Project	IEEE 802.16 Broadband Wireless Access Working Group < http://ieee802.org/16 >	
Title	Preamble Sequence For Fast Cell Search, Low Computational Complexity, and Low PAPR	
Date Submitted	2004-08-28	
Source(s)	Jason Hou Jing Wang Sean Cai Dazi Feng Yonggang Fang	jhou@ztesandiego.com jwang@ztesandiego.com scai@ztesandiego.com dfeng@ztesandiego.com yfang@ztesandiego.com
	ZTE San Diego Inc. 10105 Pacific Heights Blvd. San Diego, CA 92121 USA	Voice: 858-554-0387 Fax: 858-554-0894
Re:	IEEE P802.16e/D4-2004	
Abstract	Proposing a new DL preamble sequence design for use in IEEE P802.16e/D4-2004	
Purpose	To improve the cell search and cell synchronization in mobile environment and reduce computational complexity for extended battery standby time.	
Notice	This document has been prepared to assist IEEE 802.16. It is offered as a basis for discussion and is not binding on the contributing individual(s) or organization(s). The material in this document is subject to change in form and content after further study. The contributor(s) reserve(s) the right to add, amend or withdraw material contained herein.

Preamble Sequence For Fast Cell Search, Low Computational Complexity, And Low PAPR

Figure X. Downlink PUSC basic structure

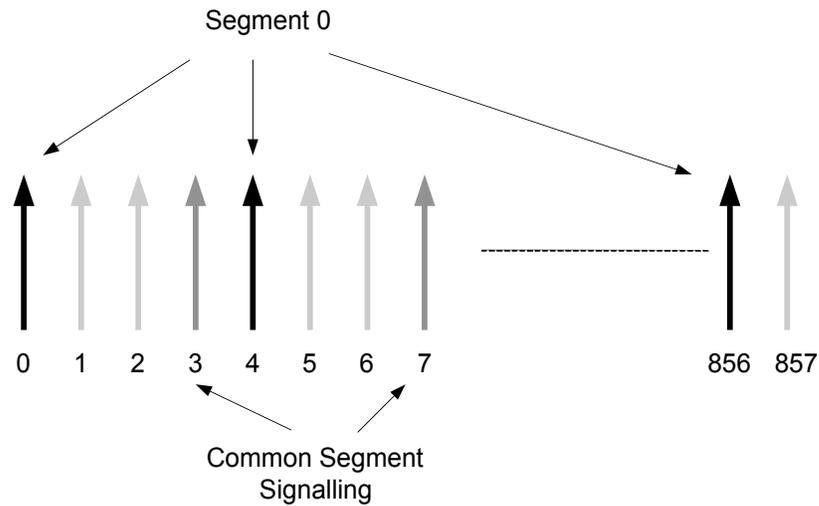
Replace IEEE P802.16e/D4 8.4.6.1.1 as follows

Each segment uses a preamble composed of a carrier-set out of the 4 available carrier sets in the following manner. The DC carrier will not be modulated at all and the appropriate element will be discarded, therefore DC carrier shall always be zeroed and guard bands be zeroed.

- Segment 0 uses preamble carrier-set 0 and additionally modulates carrier-set 3 with a segment-specific code-phase equal to $ID_{cell} 0$ as a reference signal.
- Segment 1 uses preamble carrier-set 1 and additionally modulates carrier-set 3 with a segment-specific code-phase equal to $ID_{cell} 10$ as a reference signal.
- Segment 2 uses preamble carrier-set 2 and additionally modulates carrier-set 3 with a segment-specific code-phase equal to $ID_{cell} 20$ as a reference signal.

Therefore each segment eventually modulates each 4'th subcarrier and collectively modulates carrier-set 3 without boosting for common segment signaling to establish a segment timing and frequency reference. Figure X depicts an example of the preamble of segment 0.
